Interactive comment on “The influence of precipitation and temperature input schemes on hydrological simulations of a snow and glacier melt dominated basin in Northwest China” by X. Ji and Y. Luo

X. Ji and Y. Luo

Received and published: 15 April 2013

Fig. 1. Precipitation data of Kensiwate Station and simulated streamflow

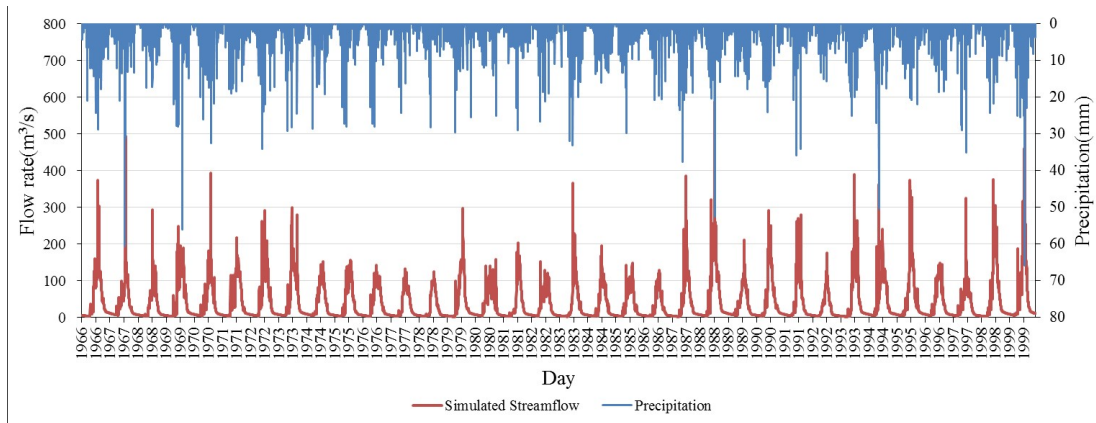
[2] There are some very high peaks in both calibration and validation [Fig.11 Calibration: year 1968 Validation: 1988] from the model generated flow should be fixed. I think the author should try surface water lag coefficient [SURLAG] for minimizing the peaks. Or it may be linked with the inconsistency with TRMM input.

Reply: As a common procedures,we first take a sensitivity analysis to all related parameters, then calibrate the most sensitivity parameters, and we spend a lot of time in this process. We have tried to adjust many parameters, included SURLAG. Adjust the surface water lag coefficient (SURLAG) could minimize the high peaks, however sometimes this may cause the peak offset and distort seasonal discharge curves.

The frequent high peaks of discharge might be due to the use of single base weather station at the low elevation and the precipitation and temperature lapse rates. This approach assumes that when there is a precipitation event at the station, there is precipitation over the basin. It is similar for the temperature. Most high peaks in the

simulated streamflow correspond to an extreme value of precipitation at the station, e.g., that happened on 1967/7/26 and 1988/7/23 as you pointed out(Figure1 of this document).
